Notice of Meeting of the Historic and Architectural Review Commission of the City of Georgetown, Texas September 11, 2025

1002 S Elm Street (2025-30-COA)

Historic & Architectural Review Commission Planning Department Staff Report

File Number: 2025-30-COA

North side
Faces E. 10th

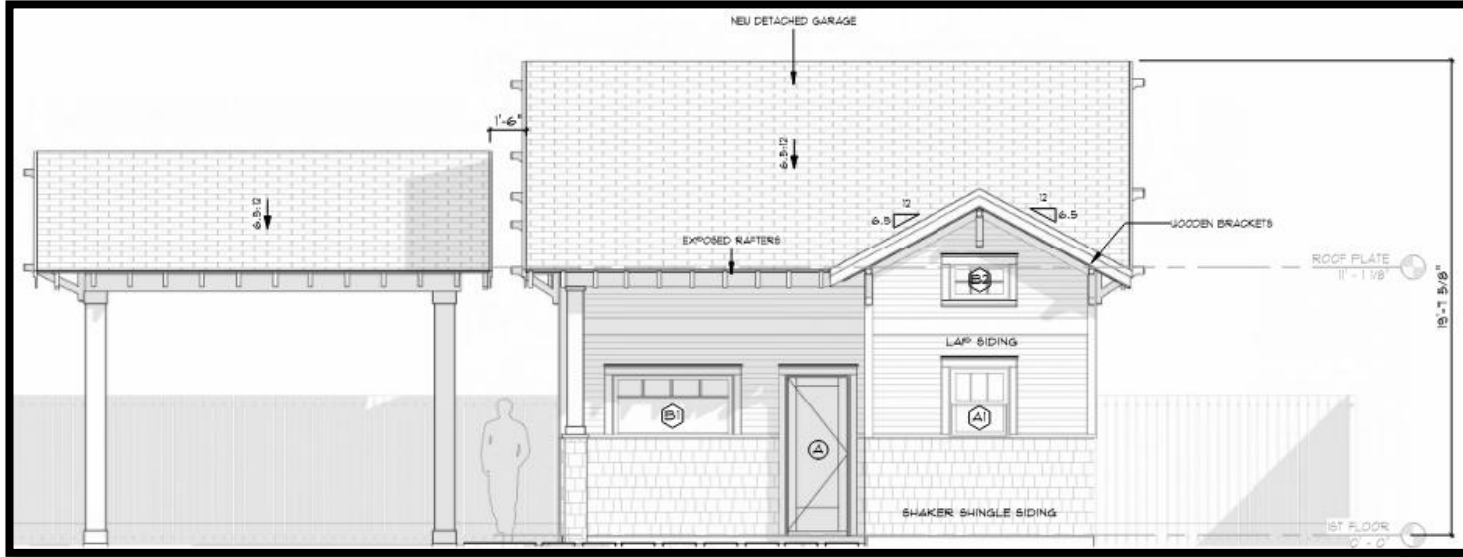
3.5.C.b The proportions of the front façade should be taller than it is wide.	Does Not Comply	The 19'-7" height of the front façade does not exceed its width of 32'-0".
G.2.a Windows should generally comprise 30-45% of the front façade.	Does Not Comply	Two windows are proposed on the character-defining façade of the garage, which faces 10th Street. The front façade is approximately 237 square feet in area, and the windows on this façade are about 24.5 square feet in area. This means that windows comprise about 10.33% of the front façade.
G.2.b The windows should be about twice as tall as they are wide and should have the same sill and head height on each floor of the building. The exception is Modern Ranch houses.	Does Not Comply	The proposed windows on the northern, 10th street façade are wider than they are tall. Staff does acknowledge that this is so that there is ample room for cedar shake siding along the bottom of the structure.

East side
Faces Elm

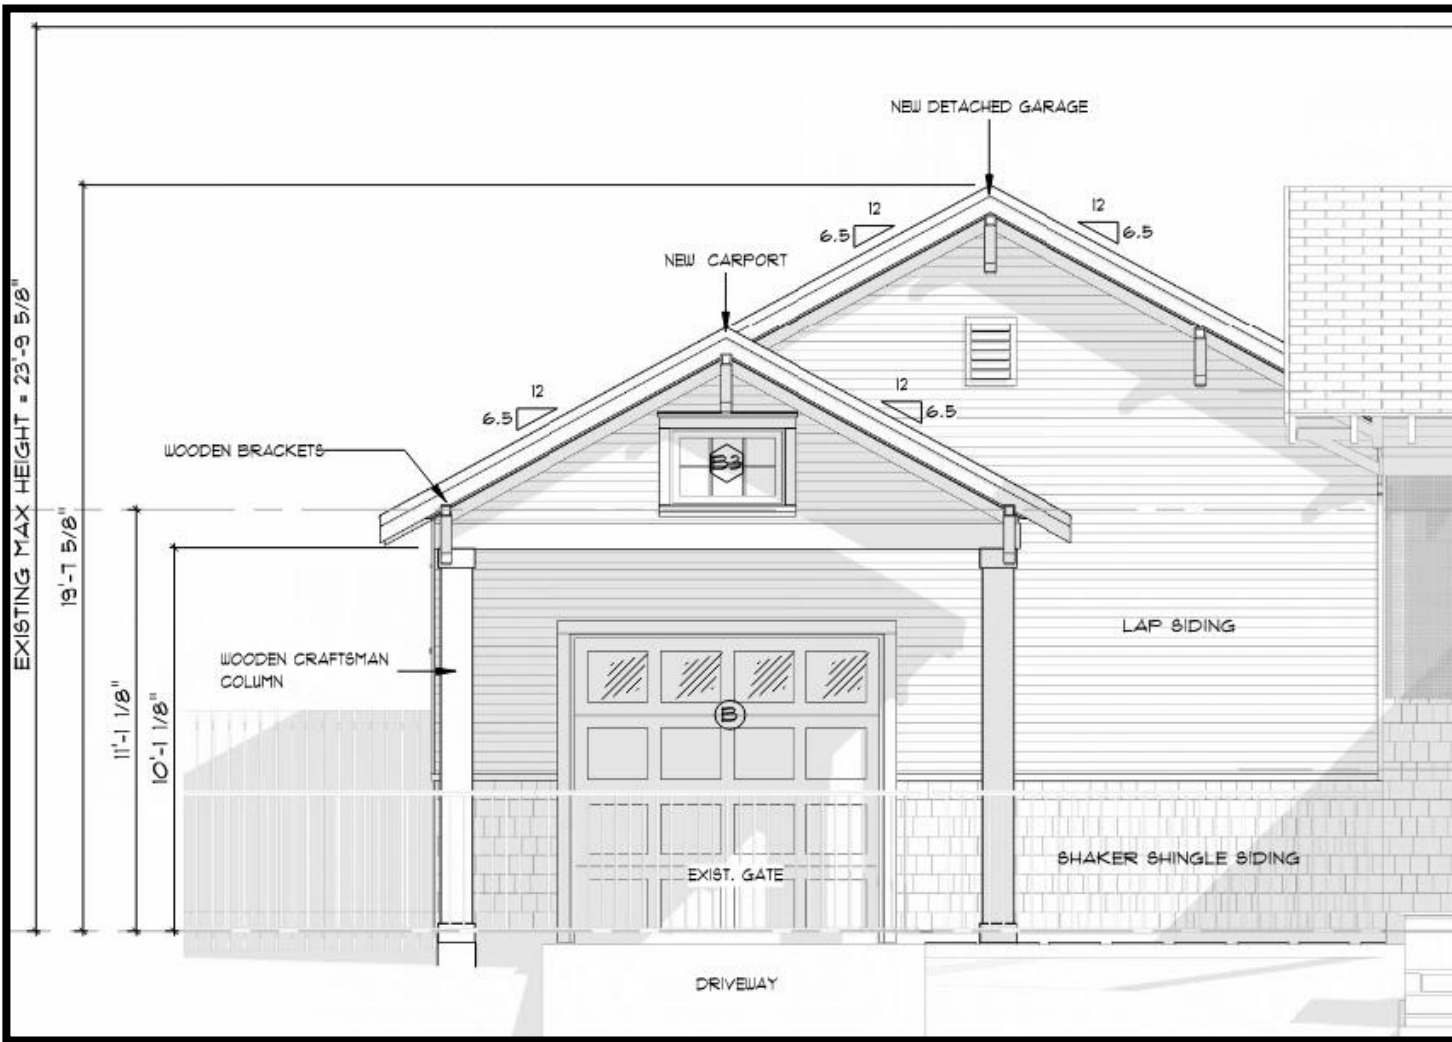
Design Guideline	Finding	Analysis
3.4.C.3.b When an addition is made to an existing garage or accessory structure, or a new building added in the rear, the new windows and doors must face into the rear yard and not into the side or rear neighbor's property.	Does Not Comply	There will be four windows on the south side of the garage, facing the yard of the neighboring property.
